**ADDENDUM #4 to PIN 072201931CPD**

Re: Medium Voltage Feeders and Substation  
Upgrades at Rikers Island

2 EXISTING R1 SUBSTATION PART PLAN  
SCALE: 1/8"=1'-0"

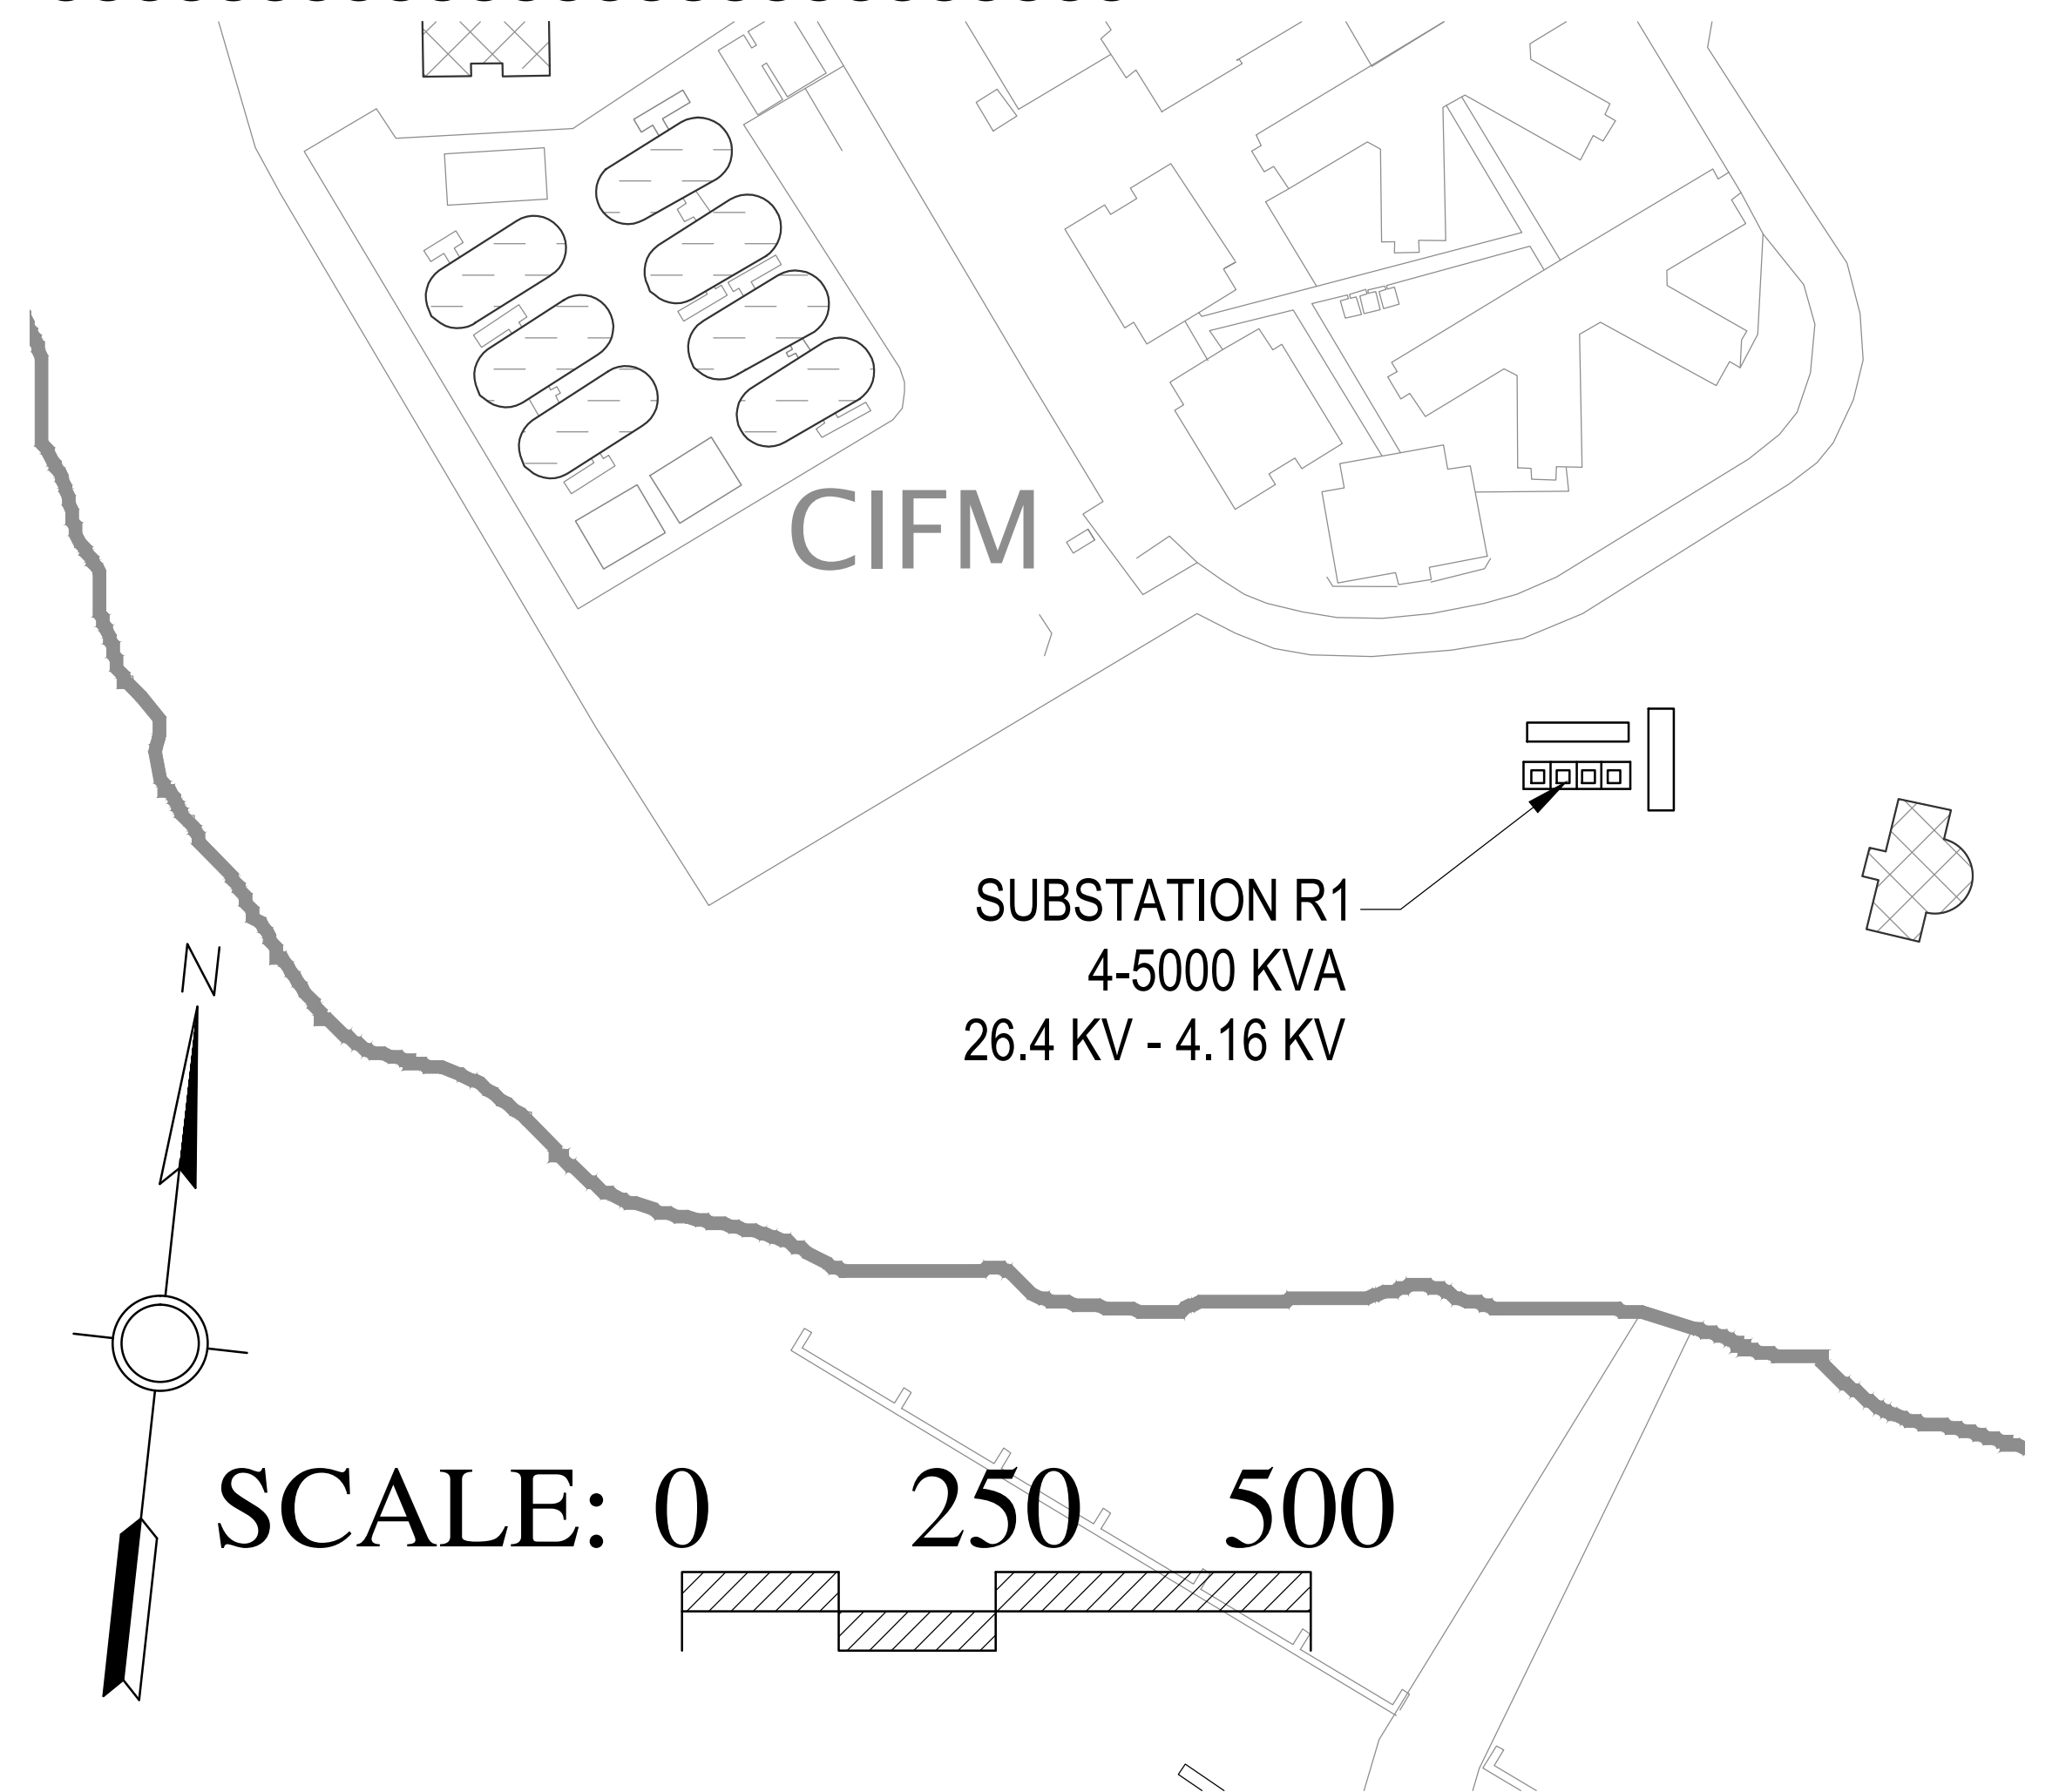
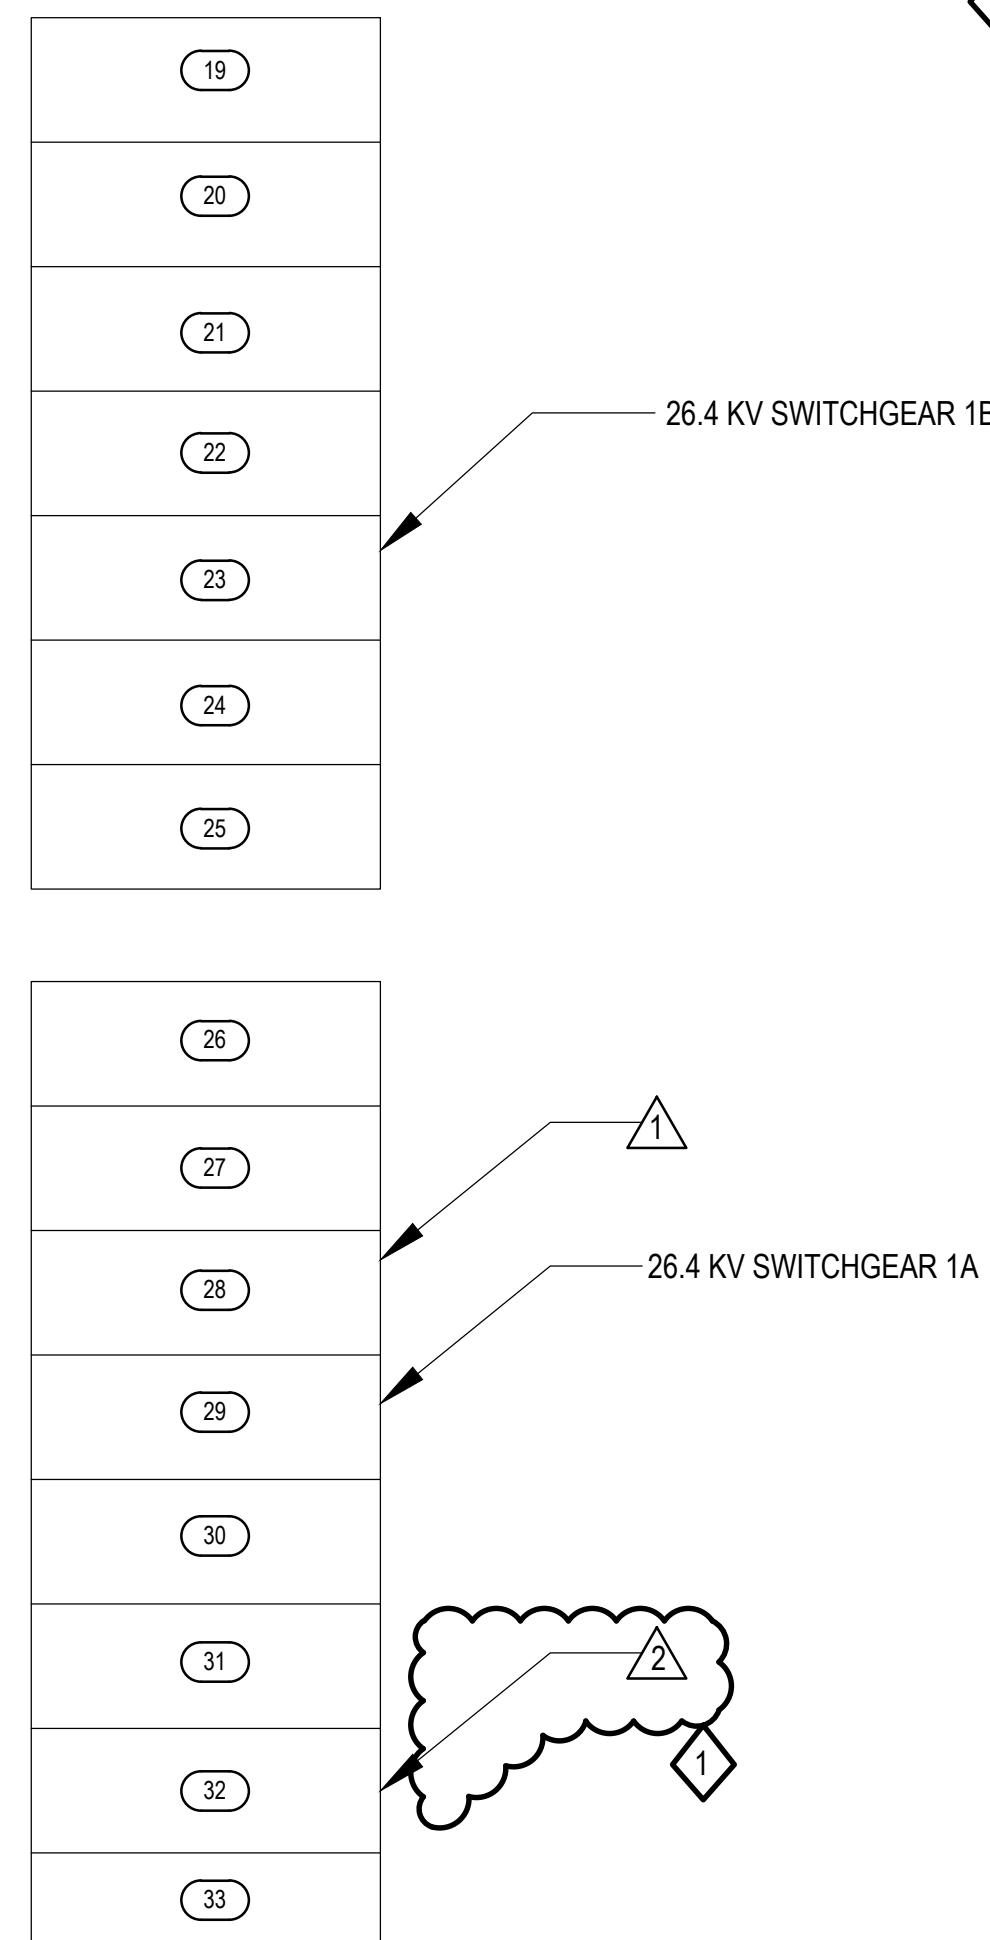
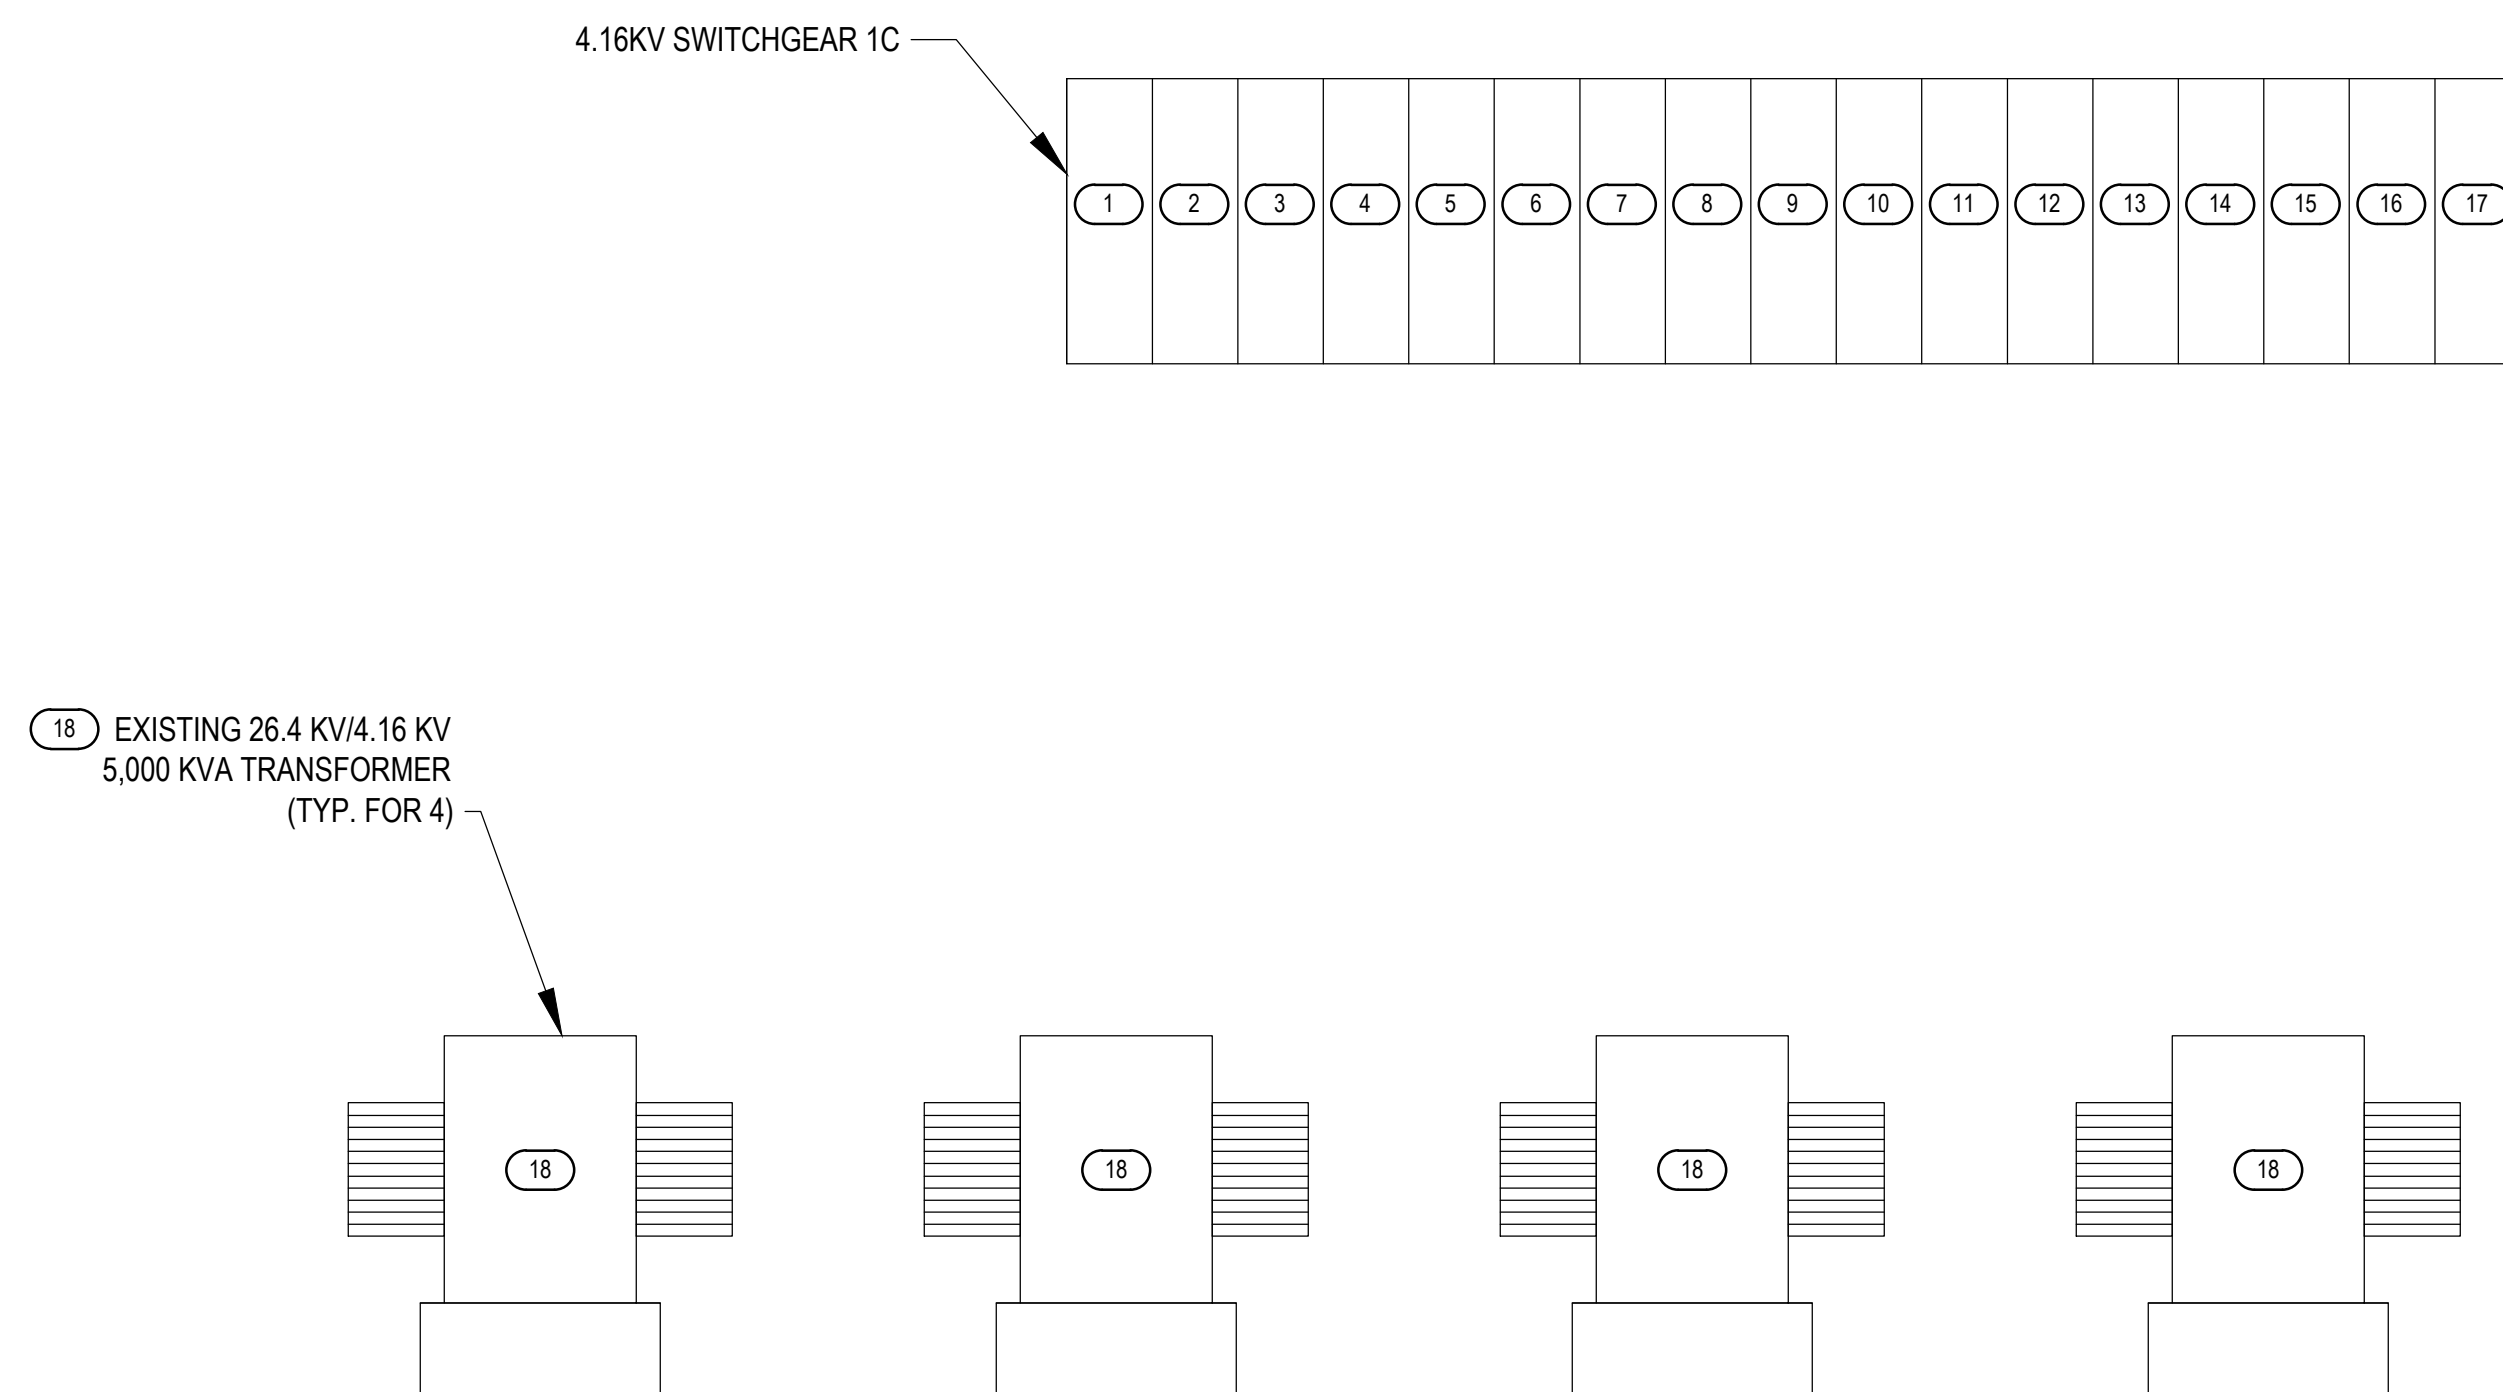
**Q.16** The damaged Vacuum Circuit Breakers: Will we be required to re-build the entire cubicle as part of the scope?

**Q.27** Will the contractors be replacing the blown Equipment?

**A.16** Scope of work is to replace only the vacuum circuit breaker and damaged parts in the cubicle.

**A.27** Yes, substation breakers and related work to be replaced.
